RAI Volume 2, Chapter 2.1.1.7, Eleventh Set, Number 15:

Provide (a) calculation of allowable bearing pressure for mat foundations of surface facility structures using appropriate strength parameters for the alluvium and limits on foundation settlement, and (b) justification for the settlement limits.

Response Tracking Number: 00428-00-00

RAI: 2.2.1.1.7-11-015

Figure 1. Allowable Bearing Capacity Versus Dimension B for a Rectangular Foundation ($L = 2B$)

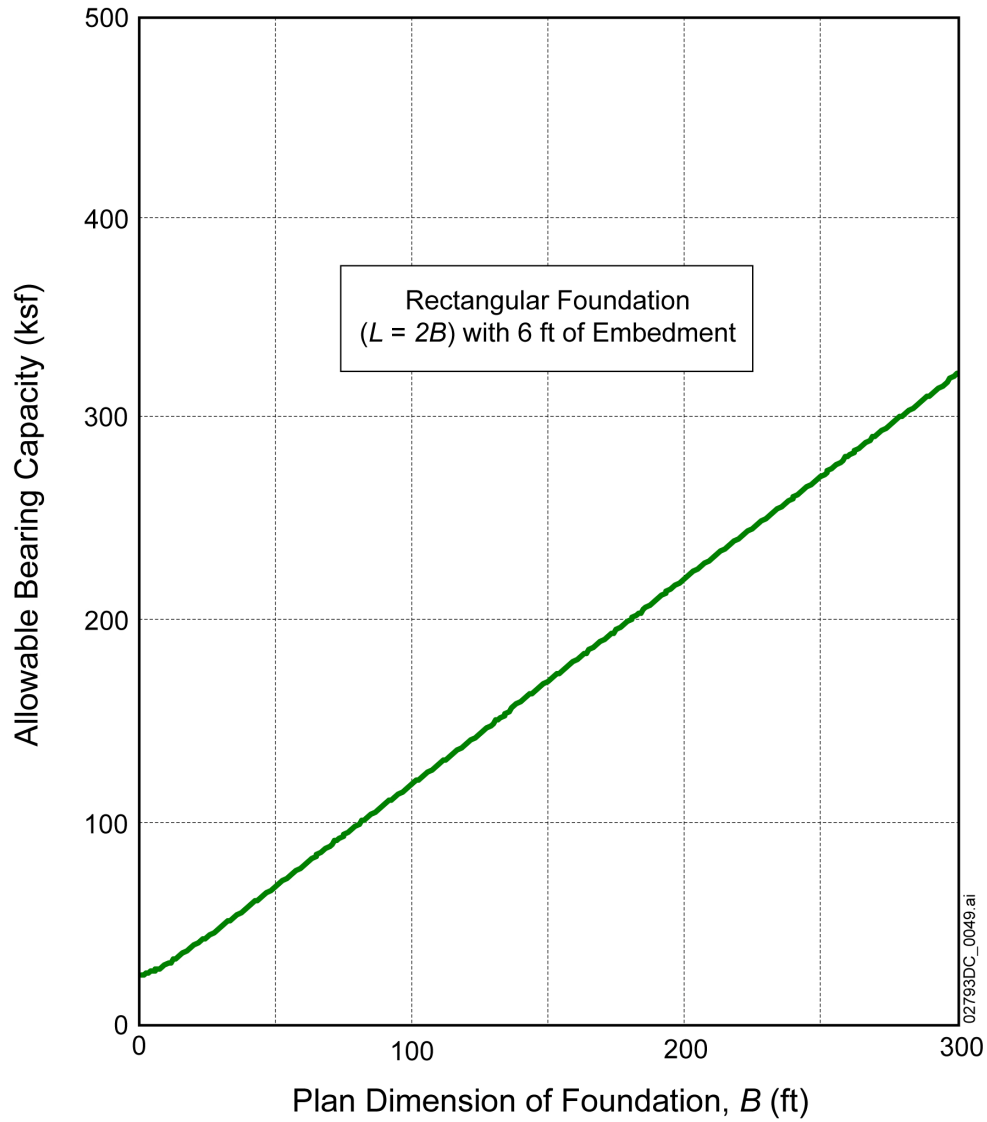
Basis: DOE selected an allowable bearing pressure of 50 ksf (BSC, 2007ba, Section 6.2.3) for surface facility mat foundations based on BSC (2007bq, Figure B6-2). However, the DOE's information (BSC, 2007bq: Figures B6-7, B6-8, and B6-13) shows that the allowable bearing pressure based on limiting the foundation settlement decreases as the foundation width increases. This information (BSC, 2007bq: Figures B6-7, B6-8, and B6-13) indicates the allowable bearing pressure for the mat foundations could be much smaller than DOE's selected value of 50 ksf. Estimating the allowable bearing pressure for foundations on cohesionless soils based on limiting the foundation settlement is consistent with long-standing geotechnical engineering practice (e.g., Terzaghi et al., 1996, p.393–405).

The allowable bearing capacity was evaluated for each facility using the dimensions of the surface facilities, typical soil properties identified in *Supplemental Soils Report* (BSC 2008, Appendix B), and the bearing capacity equations provided by *Foundation Analysis and Design* (Bowles 1996). The values are listed in Table 1. Diagrammatically, a plot of allowable bearing

capacity for a rectangular foundation (with a plan dimension ratio of 1:2) is also provided in Figure 1. This figure is similar to Figure B6-2 of *Supplemental Soils Report* (BSC 2008).

From an examination of results in Table 1, it is evident that the allowable bearing capacity for each facility is substantially in excess of the 50 ksf value, as stated in *Seismic Analysis and Design Approach Document* (BSC 2007b), and is generally larger than 90 ksf. It is also shown that the average foundation pressure (i.e., the total weight of the structure divided by the foundation area) for each facility is substantially less than this allowable bearing capacity, demonstrating that the foundation design is acceptable with regard to the shear failure of the soil. Further, the average foundation pressure for each facility meets the requirement of *Supplemental Soils Report* (BSC 2008) for a foundation pressure limit of 10 ksf for normal loads on a mat foundation.
